Amendment Notice 1

Works Approval Number W6088/2017/1

Premises
Thunderbird Mineral Sands Project
Great Northern Highway
WATERBANK WA 6725

Date of Amendment 8 October 2019

Figure 8: In-pit available void after three years of mining

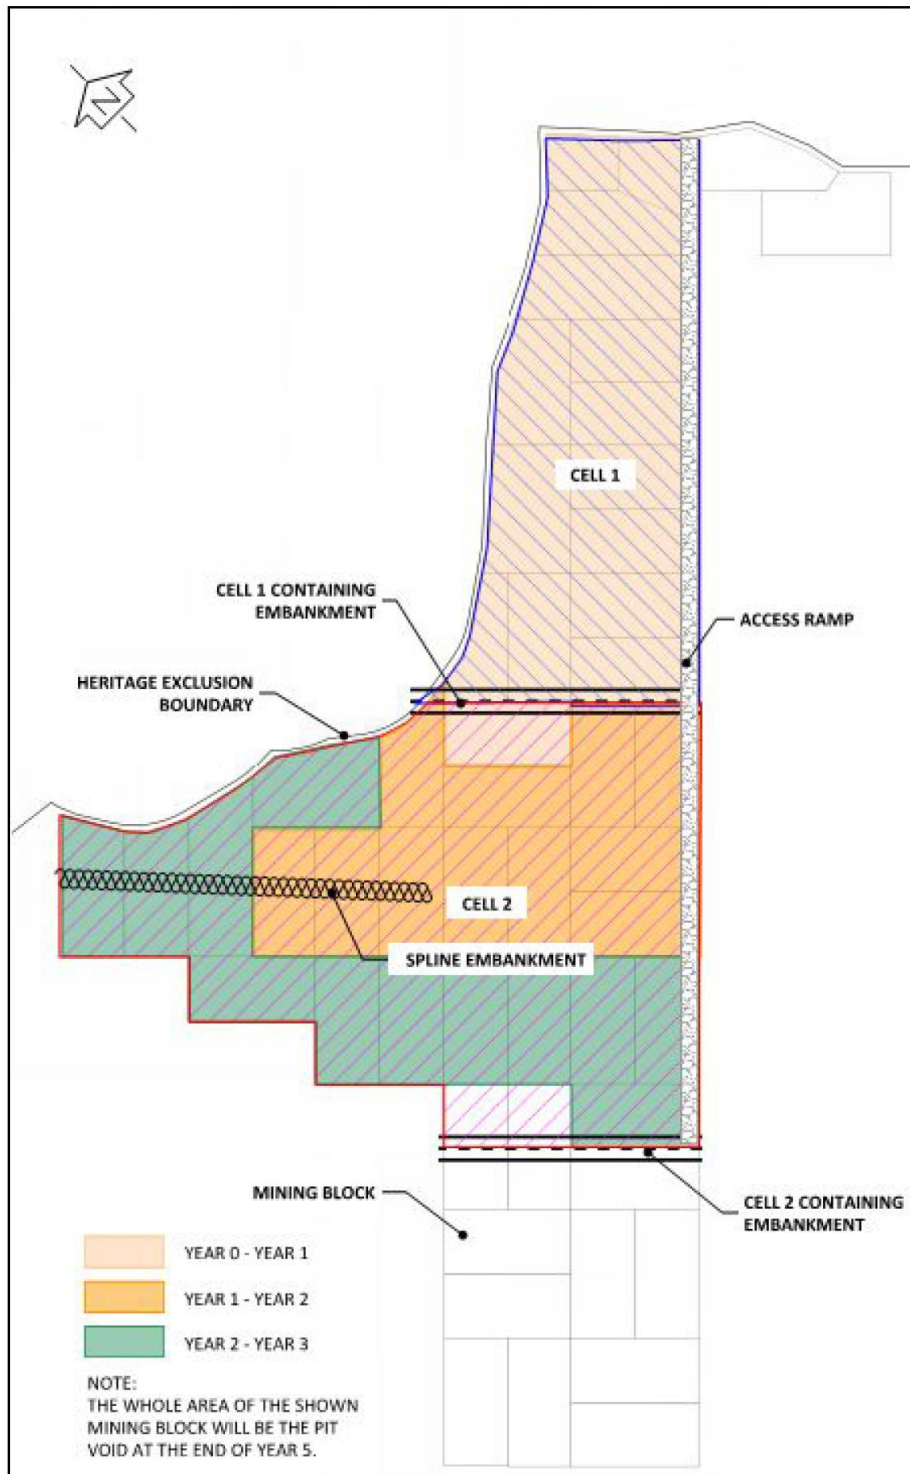
The Applicant has provided a figure (Figure 8) which shows the pit void at the end of the first three years of mining. Two cells have been considered for the initial stages of in-pit tailings storage, known as Cell 1 and Cell 2. In-pit deposition will commence at Cell 1, utilising a cross pit containment option (option 4) along the north western wall of the pit. Whilst deposition is occurring here, active mining will be downstream of Cell 2. Approximately three months of tailings can be stored before the tailings level reaches the discharge point elevation.

Deposition of tailings will then switch to Cell 2, allowing sufficient time for tailings to consolidate in Cell 1. Discharge into Cell 2 will be via a spline embankment (option 3). This embankment construction could be staged. Deposition of tailings could switch back to Cell 1 while raising the spline embankment of Cell 2.

Deposition of tailings from the northern wall of Cell 1, then along the access ramp will provide approximately one month of operation, at which time deposition can be switched back to Cell 2. Once the tailings elevation reaches the design level and sufficient time has elapsed for Cell

1 tailings drying and consolidation, a spline embankment could be constructed over the deposited tailings and tailings deposition could be carried on along the spline embankment. After this stage, tailings deposition will continue into Cell 2.

Figure 9: Tailings deposition timeline

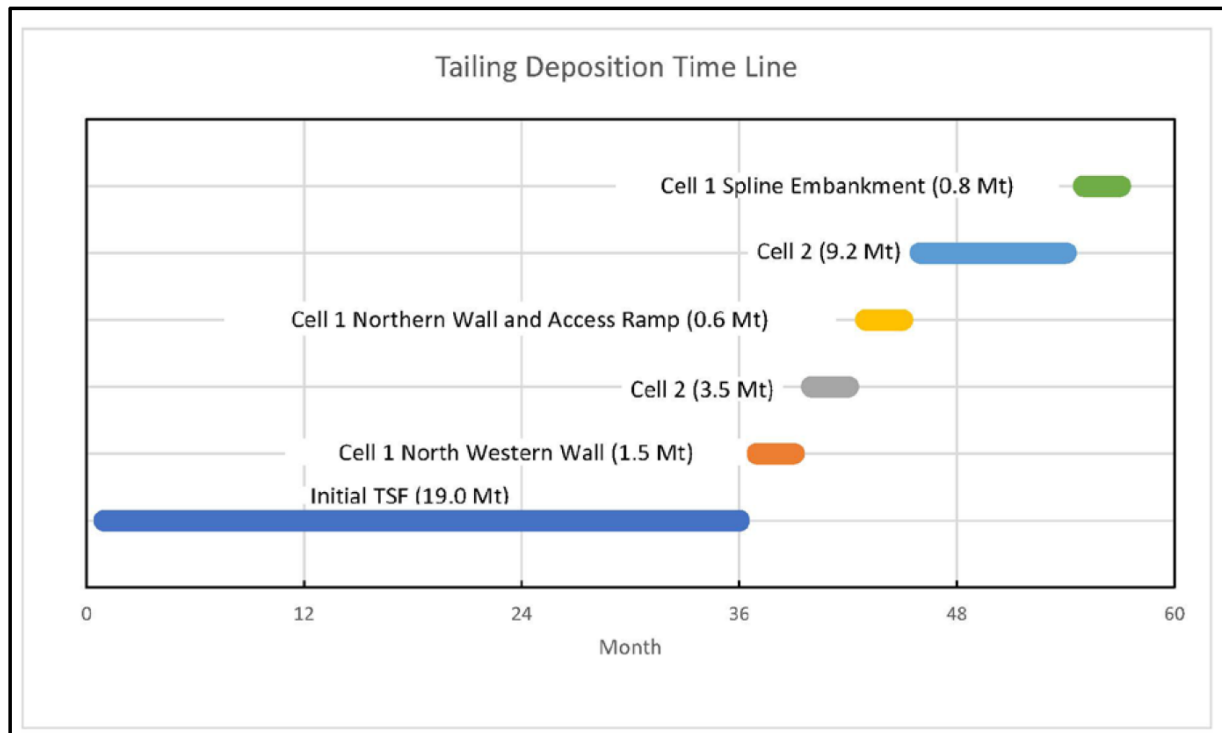
The Application also includes a figure (Figure 9) to depict a tailings deposition timeline. However, it is noted that the timeline is preliminary and could change during the operation depending on design and operation requirements.
